BOSTON EDISON COMPANY  
GENERAL OFFICES 800 BOYLSTON STREET  
BOSTON, MASSACHUSETTS 02199

License No. DPR-35  
Docket No. 50-293

Request for Additional Information for  
Pilgrim Nuclear Power Station's ISI Program

Drywell Leak Detection System Diagram  
FIGURE 4.10.1

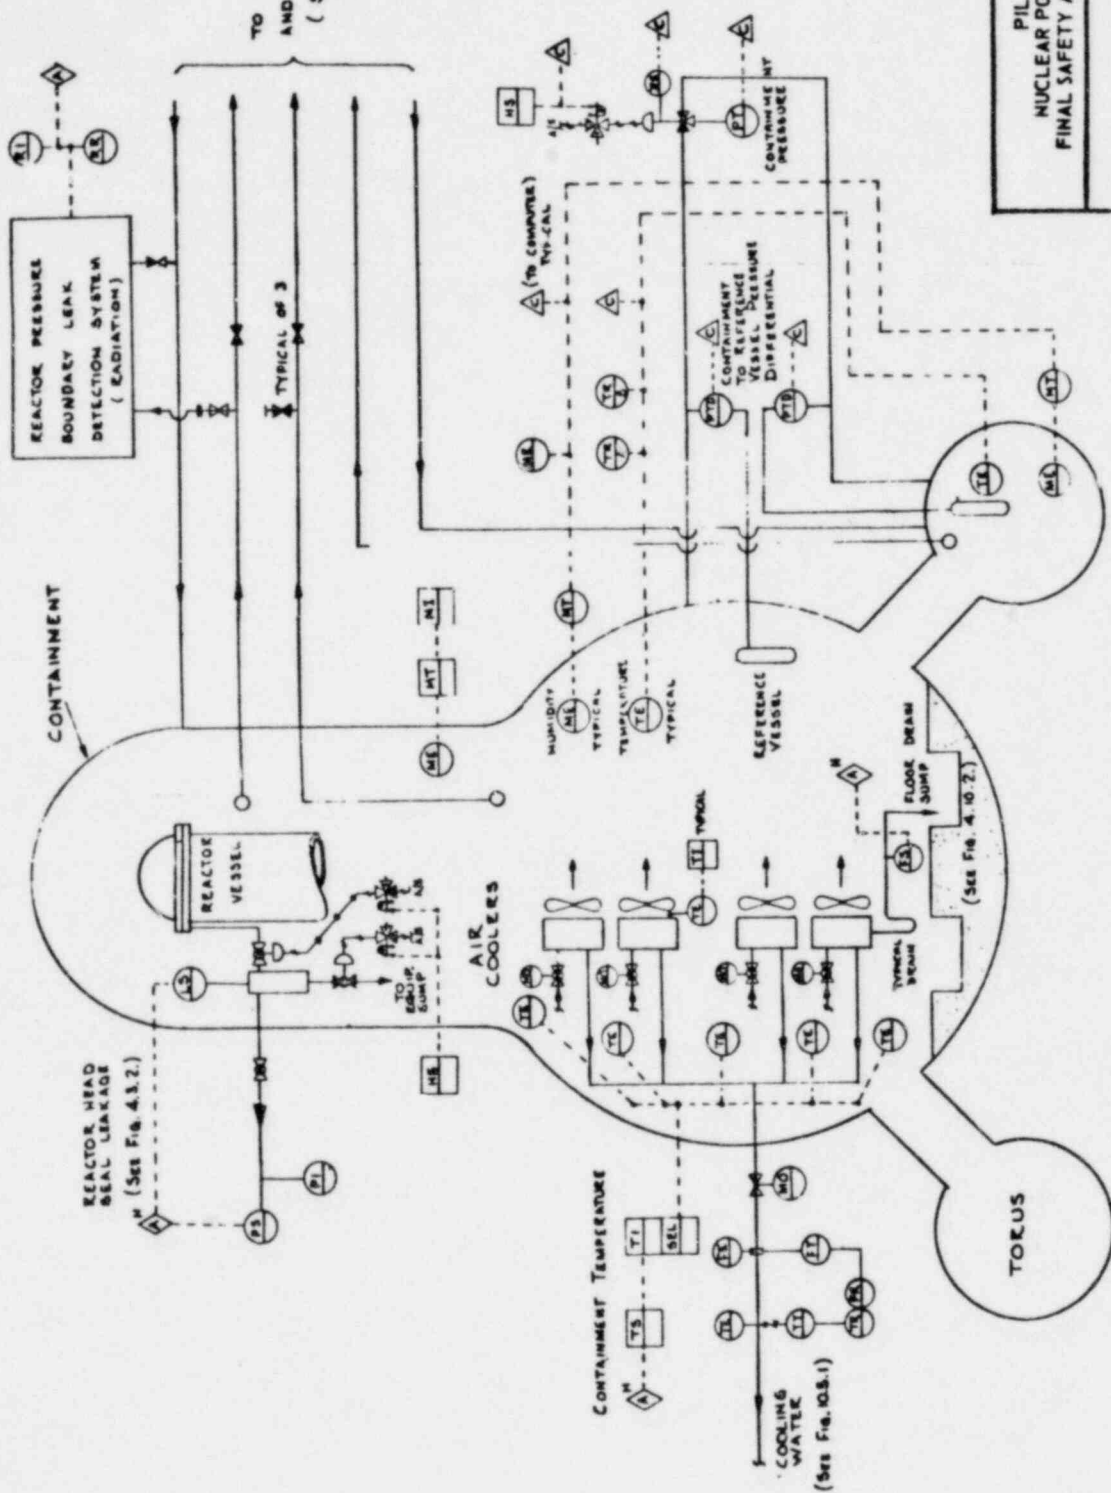
- (b) Describe the leak detection systems that would serve, and their proximity to, the areas in which these 15 pipe welds are located.
  - (c) Discuss the capability of the bellows sleeve to withstand the full dynamic effects of a longitudinal or circumferential break of the enclosed process pipe, including jet impingement, pipe whip impact, and environmental effects. If previously discussed in submittals to NRC, document by reference.

- (b) In response to questions concerning the leakage detection system BECo is providing copies of the Final Safety Analysis Report which describes the function of the leak detection system. (Attachment 1) Included with the description are the system diagrams (Fig. 4.10-1 and Fig. 4.10-2) which depict the location of the floor and equipment drain sumps.
